# UNITED STATES PATENT AND TRADEMARK OFFICE

10/530,077

<b>Office Action Summary</b>	<b>Application No.</b> 10/530,077	<b>Applicant(s)</b> BORTOLI ET AL.	
	<b>Examiner</b> DNYANESH KASTURE	<b>Art Unit</b> 3746

## **DETAILED ACTION**

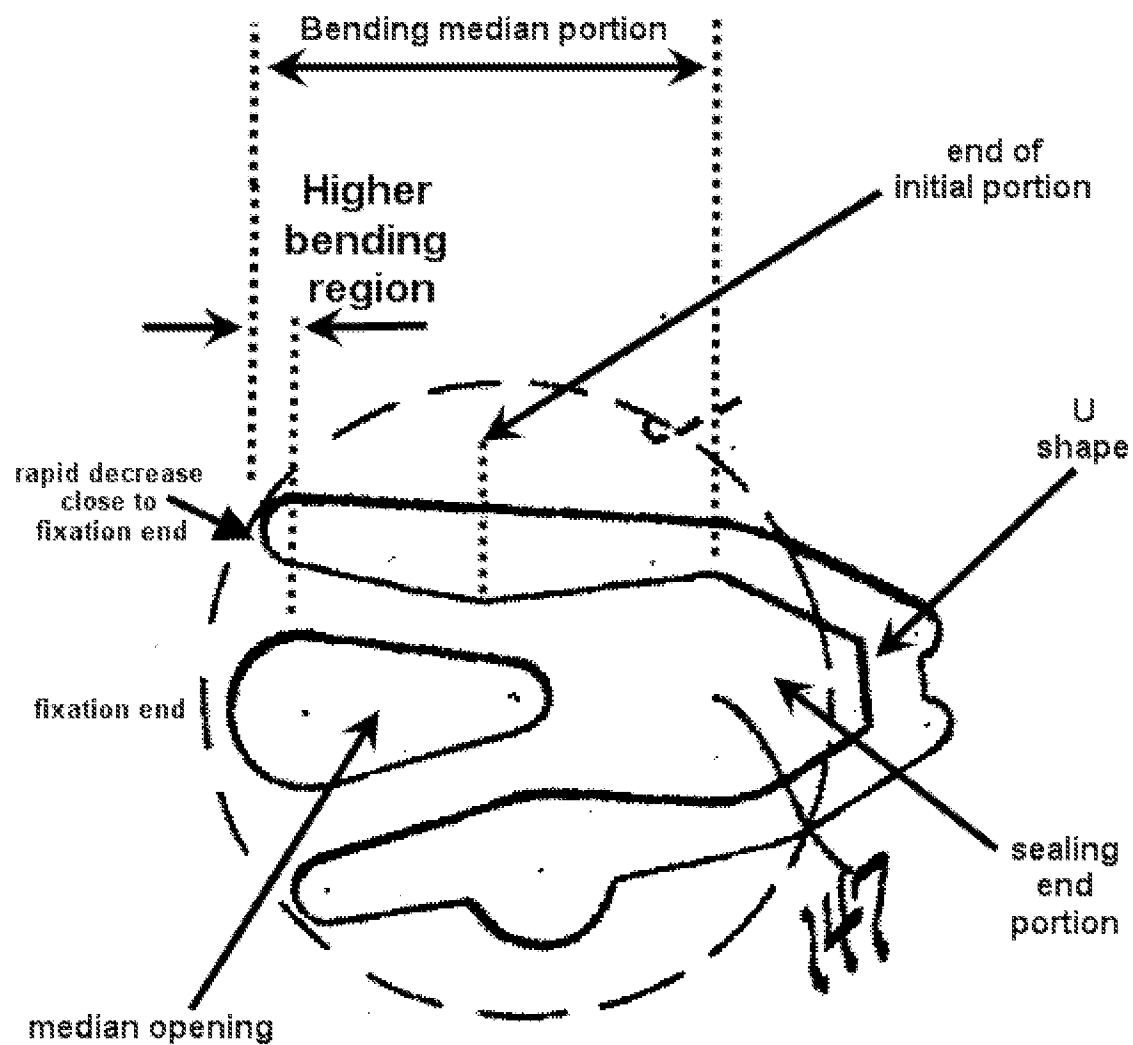
4. In Re claim 1, with reference to Figure 5 depicted above, Black et al discloses a suction valve (147) with a compression cylinder (165), which has one end closed by a valve plate (77), said valve comprising a flexible vane shaped to present:

- a fixation end portion (as depicted)
- a bending median portion (as depicted) provided with a median opening (as depicted) aligned with a discharge orifice (149) and a sealing end portion (as depicted) operatively associated with a suction orifice (145) provided in the valve plate (77)
- wherein the distance between an external edge of the flexible vane and its adjacent internal edge portion of the median opening diminishes progressively along a higher bending region from a maximum value close to end fixation portion to a minimum value at the close to the boundary of the higher bending region (as depicted above)

- the bending median portion and sealing end portion presents a U shape (as depicted)
- legs of the U shape are symmetrical about a longitudinal axis of the vane, they are equal length, and are united by the fixation end portion (as depicted, the fixation end is part of the fixation end portion)

5. In Re claim 2, Black et al discloses that the width of the median opening increases progressively from a region adjacent to the fixation end portion to the opposite boundary of the higher bending region (as depicted), whereas the total width of the flexible vane diminishes from the fixation end portion to the end of the initial portion as depicted and then it begins to progressively increase towards the sealing end portion. With regards to “from before the opposite boundary”, when the point of reference is the tip of the U shape, the end of the initial portion is “before” the “opposite boundary of the higher bending portion”.

6. In Re claim 5, Black et al discloses the distance between the external and internal edges diminishes more rapidly close to the fixation end portion than along the rest of the higher bending region.

**Table A-9**

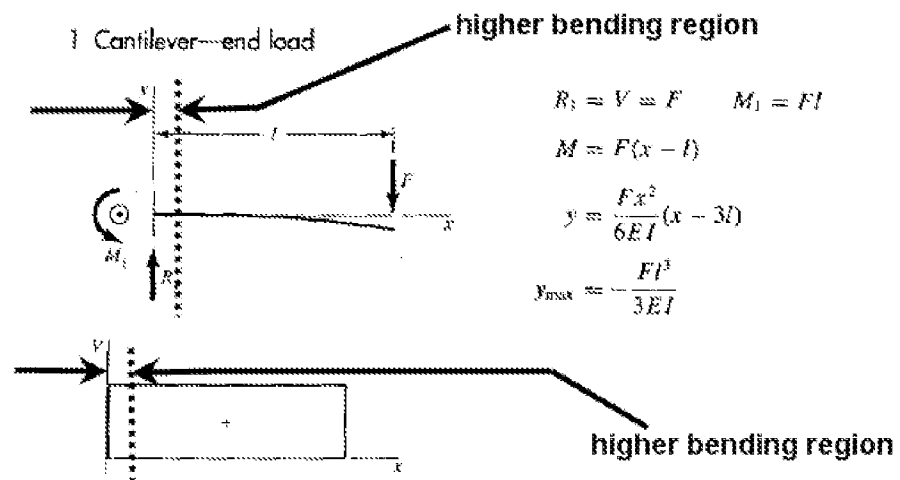
- with reference to Shigley et al, Table A-9 above depicts a cantilever (flexible vane) under end load (force due to suction in an open position of the vane). As evidenced from the shear force diagram, the shear force ( $V$ ) resulting from the opening of the valve is uniformly distributed along the higher bending region NO MATTER HOW SMALL the higher bending region is. Further, as evidenced from the deflection ( $y$ ) diagram, the deflection of the vane ( $y$ ) is NOT a linear function of ( $x$ ) implying that the vane has a curved shape in the higher bending region NO MATTER HOW SMALL the

higher bending region is. Therefore the vane IS bent in the higher bending region (due to its curved shape)

FIG. 4

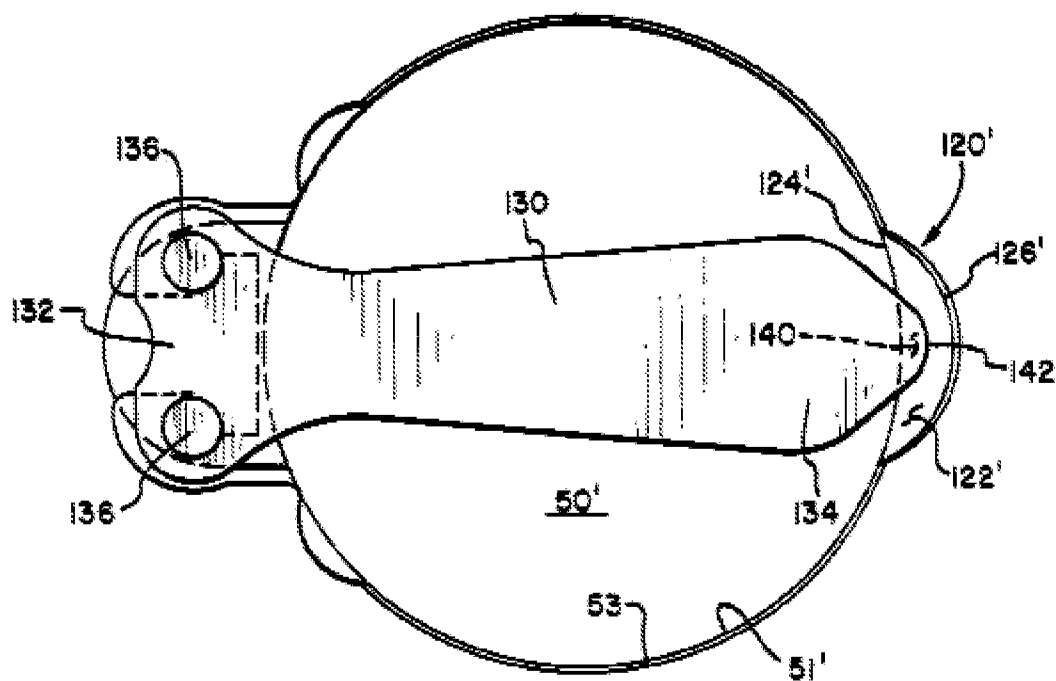
18. In Re claim 2, Black et al discloses that the width of the median opening increases progressively from a region adjacent to the fixation end portion to the opposite boundary of the higher bending region (as depicted), whereas the total width of the flexible vane diminishes from the fixation end portion to the end of the initial portion as depicted and then it begins to progressively increase towards the sealing end portion.

19. However, Black et al does not disclose "from before the opposite boundary", when the point of reference is the base at the fixed end.

20. Nevertheless, Kandpal discloses that the total width decreases at first but then progressively increases "from before the opposite boundary of the higher bending region".

21. It would have been obvious to a person having ordinary skill in the art at the time of the invention to modify the contour of the vane of Black et al so that the width progressively increases "from before the opposite boundary of the higher bending region" as taught by Kandpal as an alternative design choice for the contour of the vane.

**Table A-9**

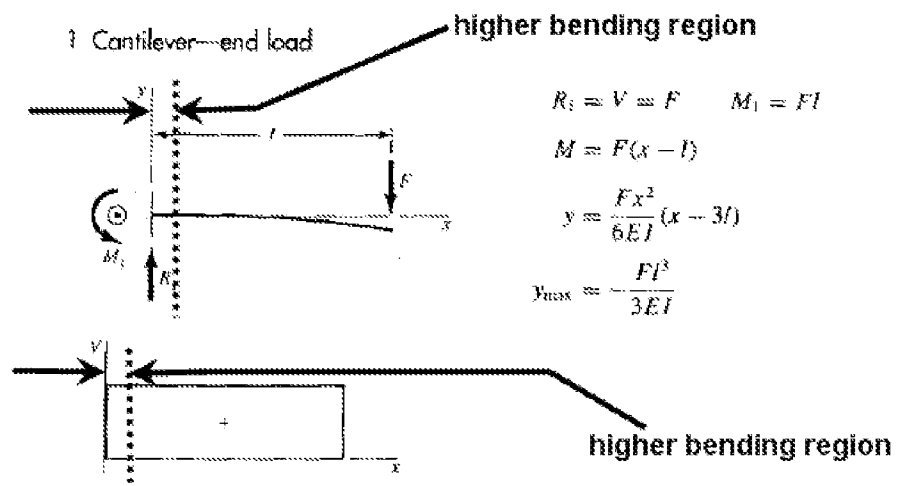
22. Applicant has argued that the structure of Black et al could not distribute opening forces and allow the reed to be bent along the higher bending region because the higher bending region is very small (fraction).

23. Examiner's Response: As discussed in the rejection of claim 1, the shear force ( $V$ ) resulting from the opening of the valve is uniformly distributed along the higher bending region NO MATTER HOW SMALL the higher bending region is. Further, the deflection of the vane ( $y$ ) is NOT a linear function of ( $x$ ) implying that the vane has a curved shape in the higher bending region NO MATTER HOW SMALL the higher bending region is. Therefore the vane IS bent in the higher bending region (due to its curved shape).
